GROUP	MODEL
ELE	2025MY EV9 (MV1a)
NUMBER	DATE
392	August 2025

TECHNICAL SERVICE BULLETIN

BSA REPLACEMENT GUIDANCE

MV1a	MV1
13271-06007K (Nut)	11254-06206B (Bolt)

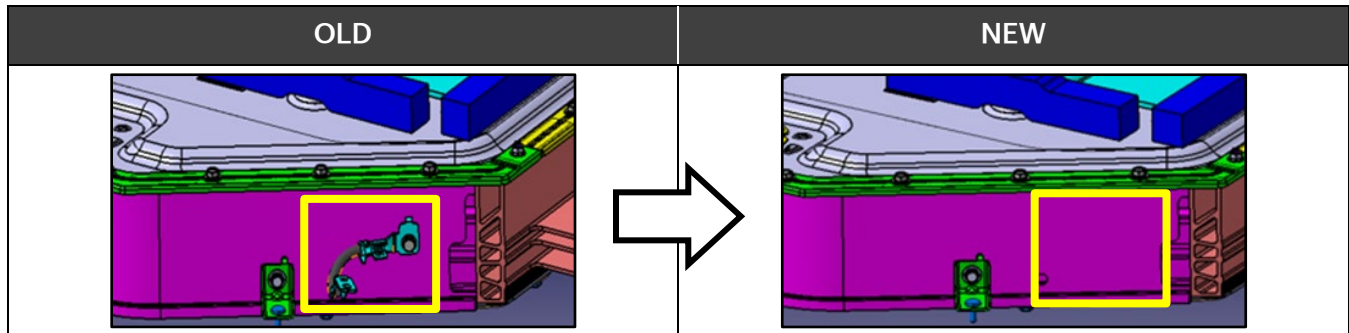
- The 'Front Under Cover Assy' is a similar design on both MV1 and MV1a. However **the fixing nuts on the front under cover were changed to fixing bolts.**

Note: Use Bolt 11254 06206B when replacing the BSA with part numbers 37501 DO050 or 37501 DO150.

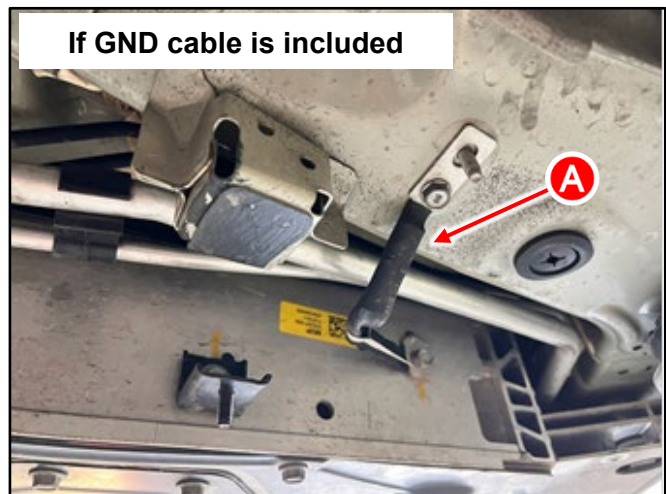
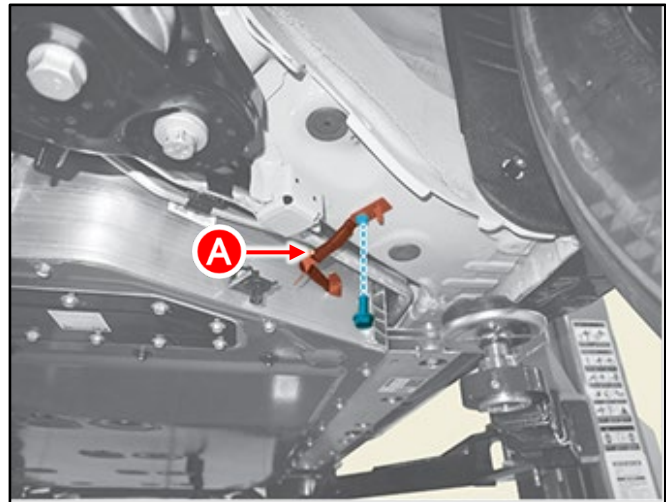
- If the replacement Battery System Assembly (BSA) includes a ground (GND) cable (A), then replace both the BSA and the GND cable** using the newly supplied components, by referring to Battery Control System → High Voltage Battery System → Battery System Assembly (BSA) → Removal and Installation in KGIS.

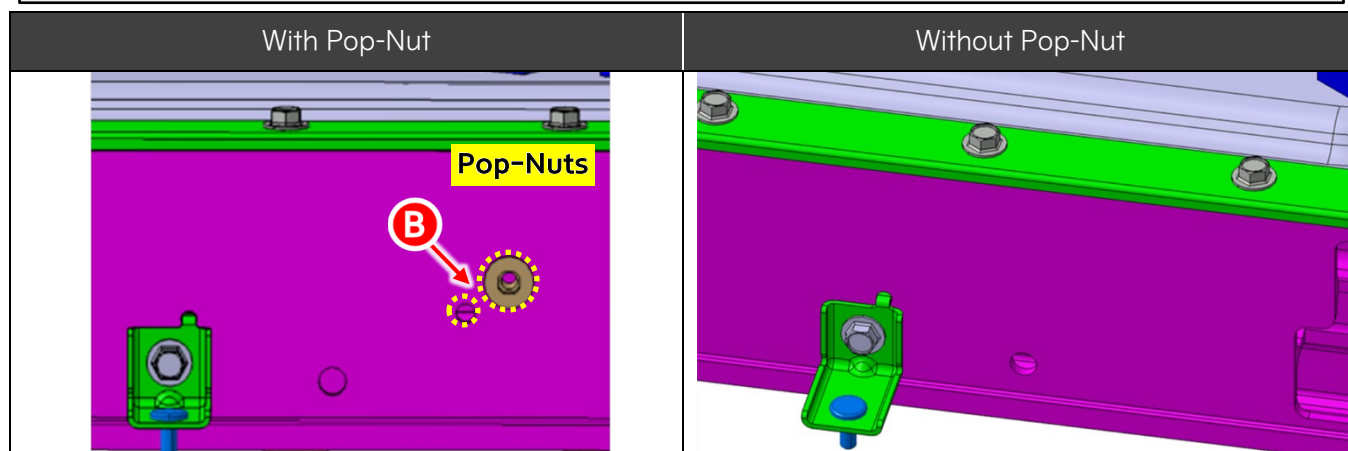
- If the replacement Battery System Assembly (BSA) does not include a ground (GND) cable, then the GND cable does not need to be installed.

Some Battery System Assemblies (BSA) may feature pop-nuts (B) on the case; however, the presence of pop-nuts does not necessarily indicate that a ground (GND) cable should be installed.
